**NUCLEAR REGULATORY COMMISSION**

Title: Advisory Committee on Reactor Safeguards  
Subcommittee on Power Upgrades

Date: Tuesday, November 29, 2005

ADVISORY COMMITTEE ON REACTOR SAFEGUARDS (ACRS)  
SUBCOMMITTEE ON POWER UPRATES

Figure 1: Modification Locations

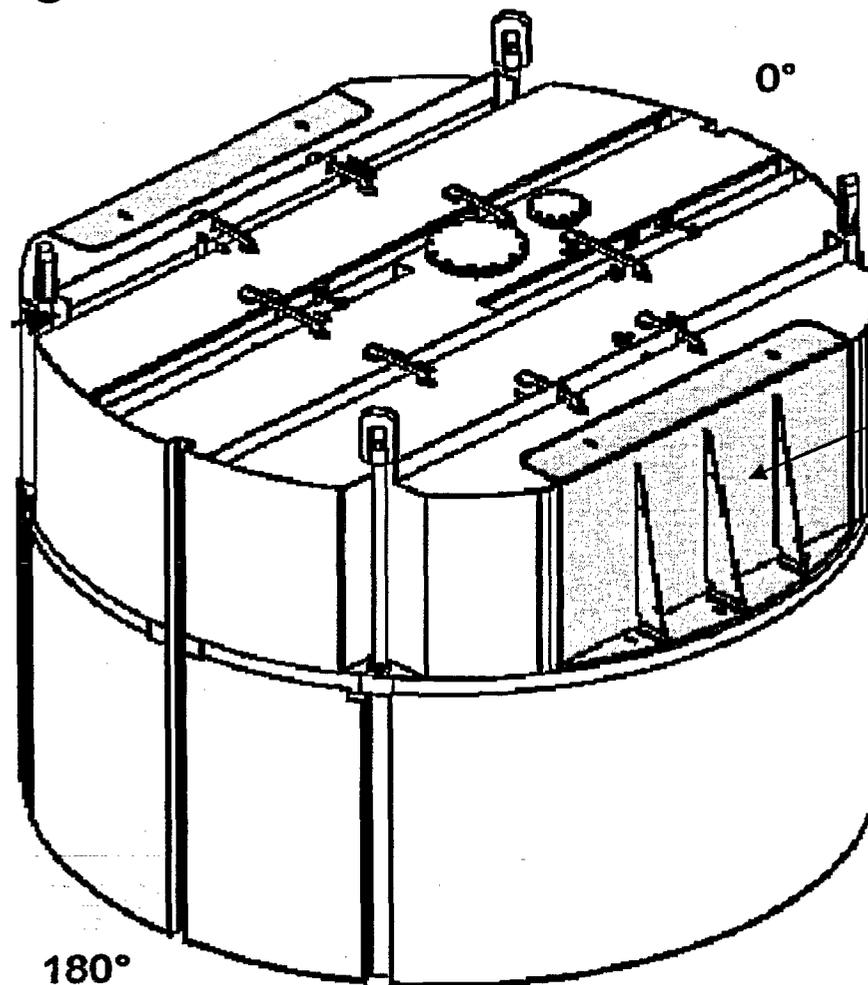
10 MEMBER SIEBER: Before you leave this  
11 picture, it seems to me that I recall that this dryer  
12 does not have the perforated mesh plates in it that  
13 lighter dryers have and that you intend to install  
14 them. Can you show me where those would fit on here?

2 The VY dryer modification installed in  
3 April 2004 consisted of strengthening of areas  
4 adjacent to the main steam line nozzle shown here in  
5 the highlighted locations, which are vulnerable, as  
6 shown in other BWRs with square hood dryers.

7 The modification consisted of replacement  
8 of the original half-inch outer hood vertical plate,  
9 which you can see here is the area on the vertical  
10 portion of the front hood.

11 Also, we replaced the original  
12 quarter-inch-thick lower horizontal cover plate with  
13 five-eighths-inch-thick plate. We added 3  
14 55-inch-tall gussets to the outer vertical plate and  
15 cover plate junction to increase stiffness.

15 MR. HOBBS: We do not plan to install  
16 perforated plates. We have a steam separator that is  
17 highly efficient relative to other BWR-free units. So  
18 our steam quality coming out of our separator is high  
19 enough that we can work without having a perforated  
20 plate.

**Figure 3: Completed Modification – Outer Hood, Cover Plate, Gussets**

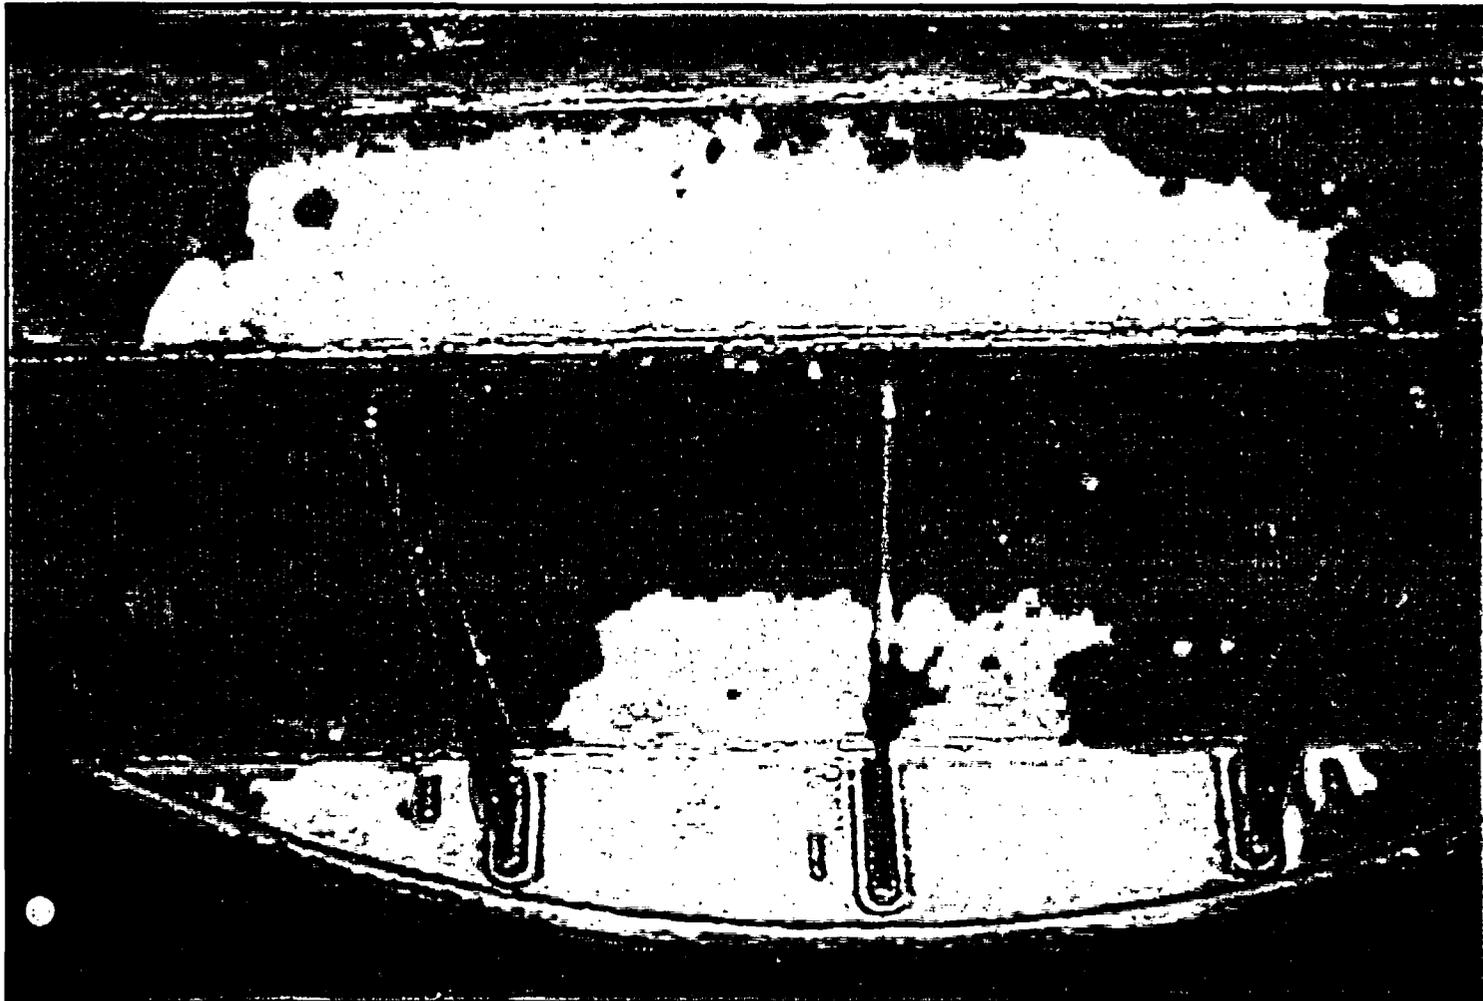
15 MR. HOBBS: Right. This is a photo of the  
16 modification being installed in 2004. And this shows  
17 the completed Vermont Yankee dryer-strengthening  
18 modification. Here you can see the new gussets and  
19 the new faceplate and the lower cover plate.

12           DR. BANERJEE: Now, if you don't remove  
13 whatever is causing the vibration, this is going to  
14 continue to vibrate, right? And eventually it will  
15 crack again or not?

15 DR. BANERJEE: Adding those gussets, of  
16 course, gives you additional vortex shedding because  
17 the flow goes across them now. So you've added some  
18 additional sort of modes due to those gussets  
19 themselves, --

8           MR. HOBBS: Yes. Other boiling water  
9 reactors with square hood dryers have installed this  
10 same modification here. And it has been shown to  
11 improve the strength of the dryer.

5 So this modification takes care of some of  
6 the low-frequency excitations that typically can occur  
7 inside the domes themselves. And it moves the  
8 fundamental vacancy of this dryer face well above the  
9 standard frequencies, driving frequencies. So it  
10 keeps the structure coupling with the --

**Figure 5a: VY Strain Gage Measurements vs. Quad Cities (Log) Steam Line Data PSD Comparison QC2 (OLTP & EPU) vs. VY 100% (CLTP)**

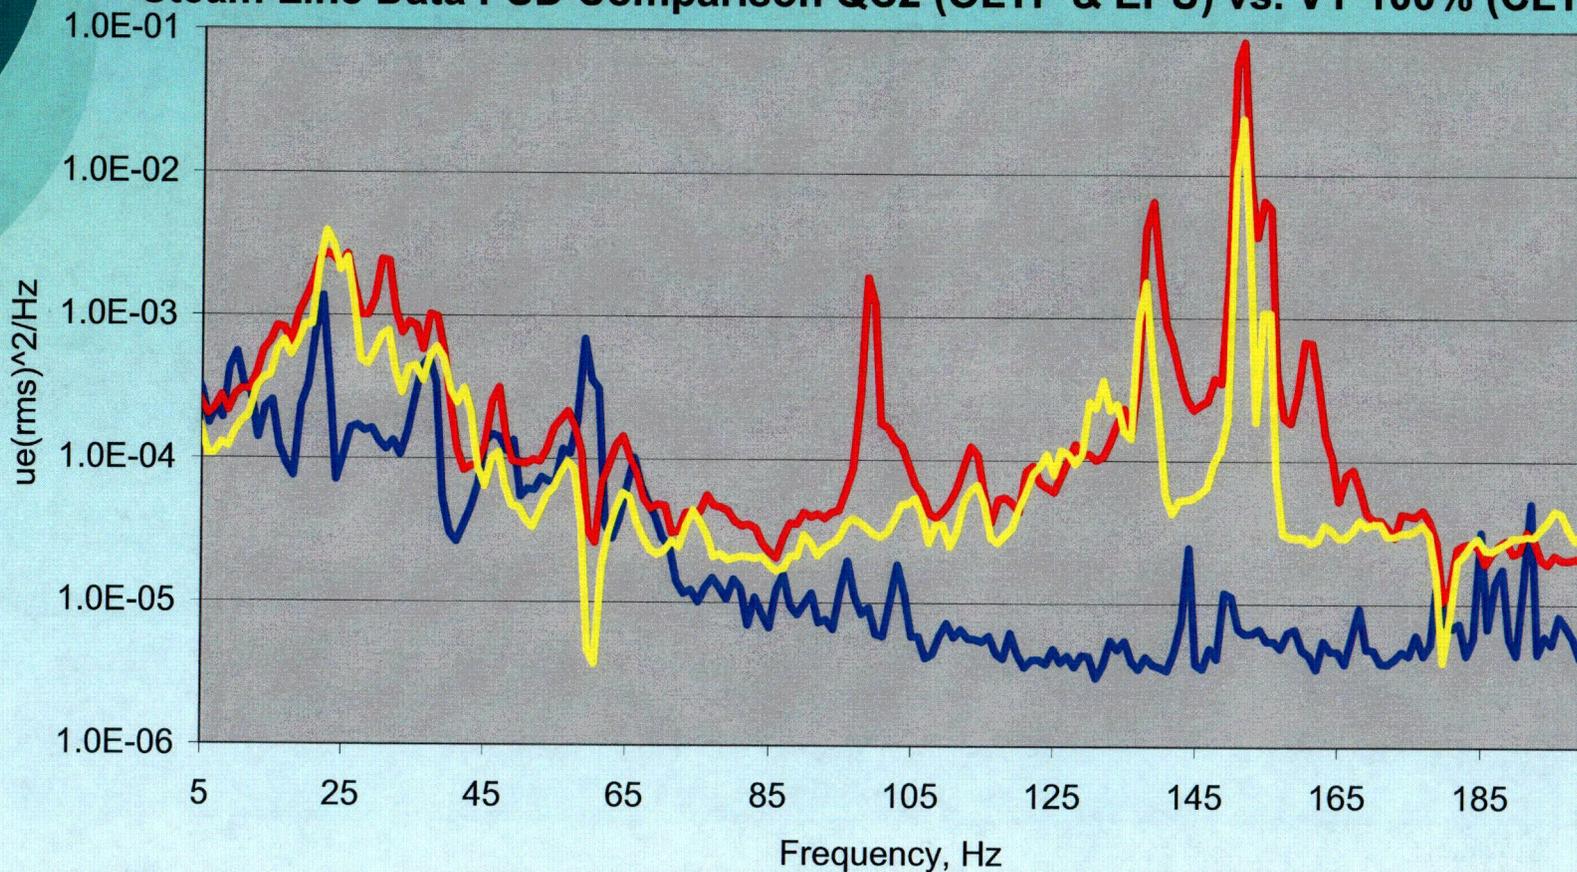
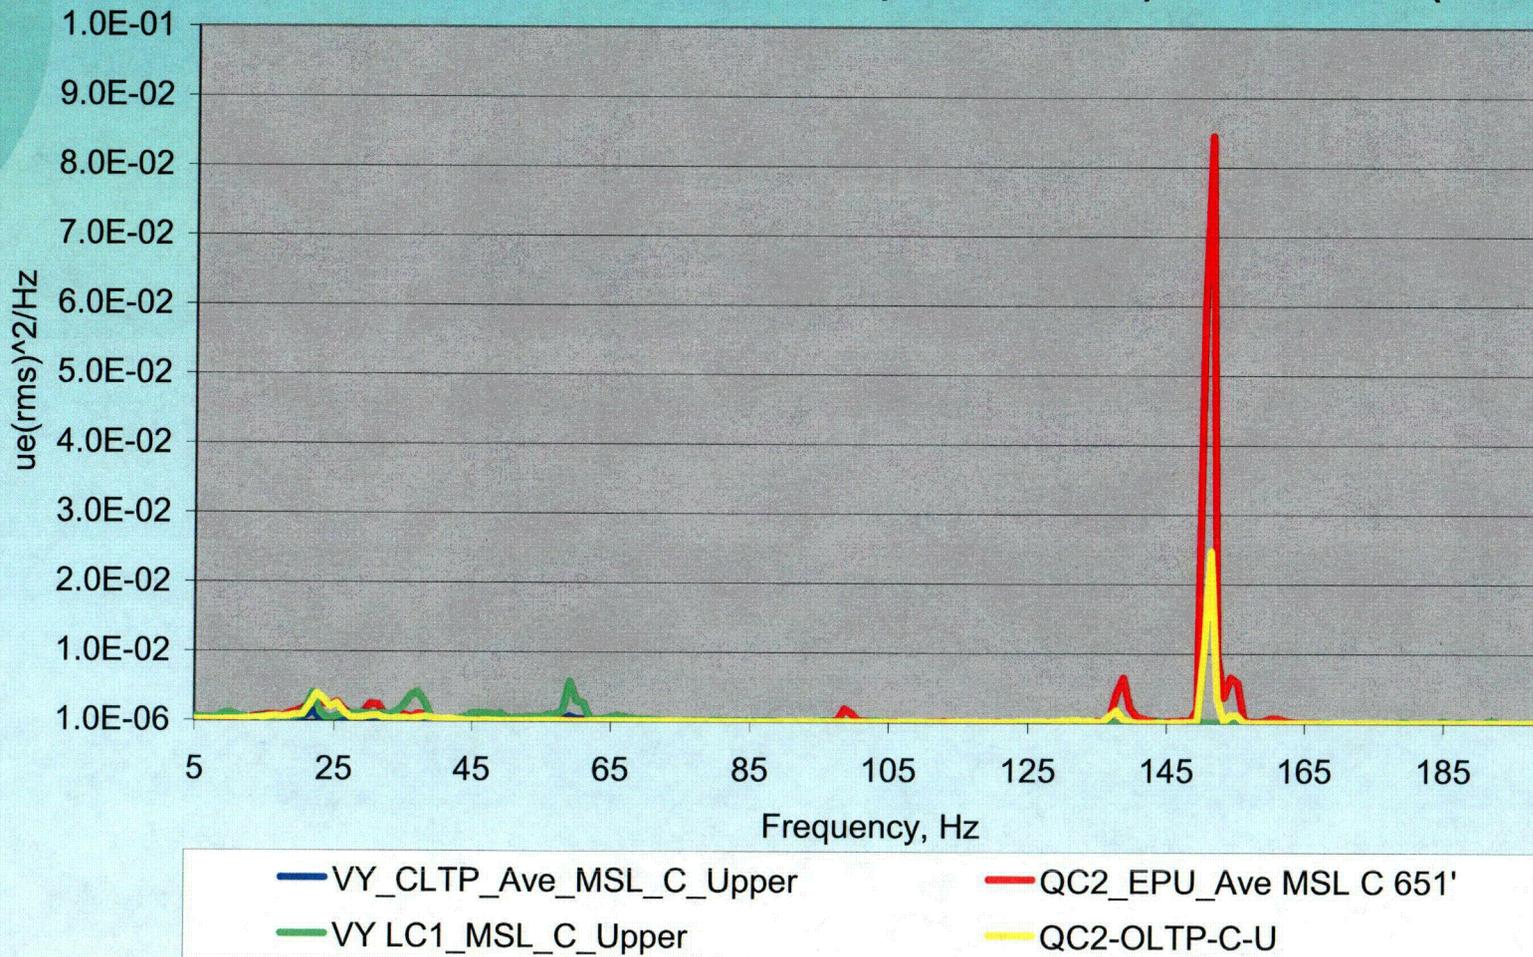
18 Next slide. This figure adds the Quad  
19 Cities vibration data in log-scale still for operation  
20 at EPU conditions. And if you go to the next slide,  
21 this is on a linear scale.

22 So you can see that there is a significant  
23 increase in the Quad Cities acoustic resonance levels  
24 at EPU conditions in this figure here. And at Quad  
25 Cities, EPU exacerbated the previously existing

7 CHAIRMAN DENNING: Another comment. And  
8 that is now the frequency at which we saw in Quad  
9 Cities, this big peak, is way above the area that is  
10 related to where your strengthening occurred, right?

18 MR. HOBBS: That's correct.

**Figure 6: Potential Cavity Resonance Range vs. Main Steam Velocity**

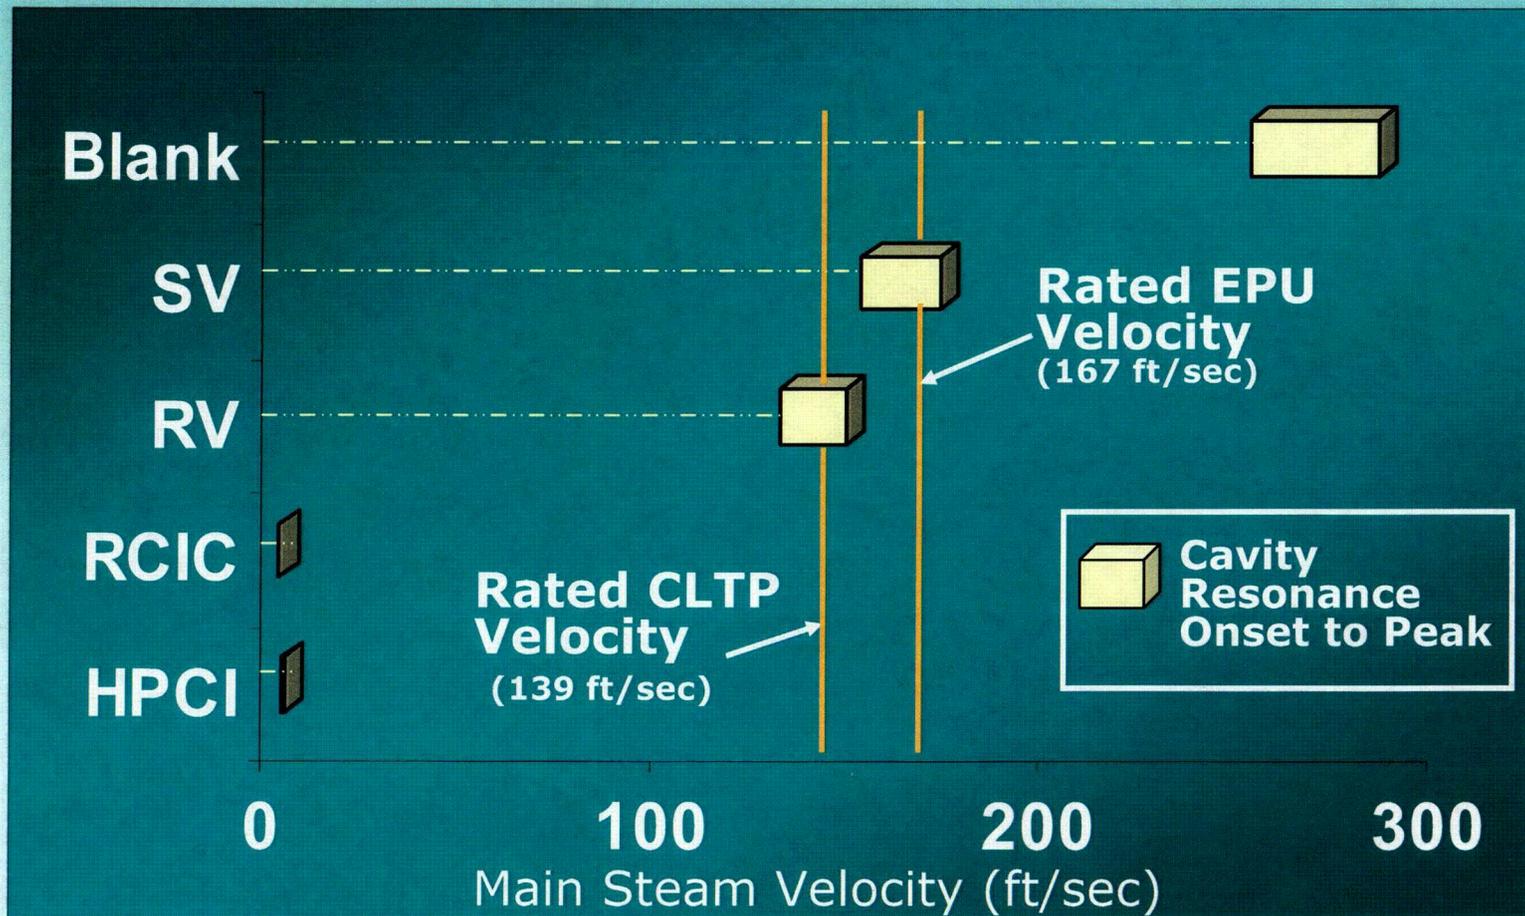
11 And you can see that for the rated current  
12 Vermont Yankee velocity of 139 feet per second, the  
13 relief valves have predicted onset of resonance and  
14 full resonance in that block there. And at EPU  
15 condition, you can see the safety valves would show  
16 potential onset for resonance.

21 DR. BANERJEE: Just a question. At the  
22 entrance to the steam line and that cavity which is  
23 formed at the dryer, is there sort of potential for  
24 resonances there?
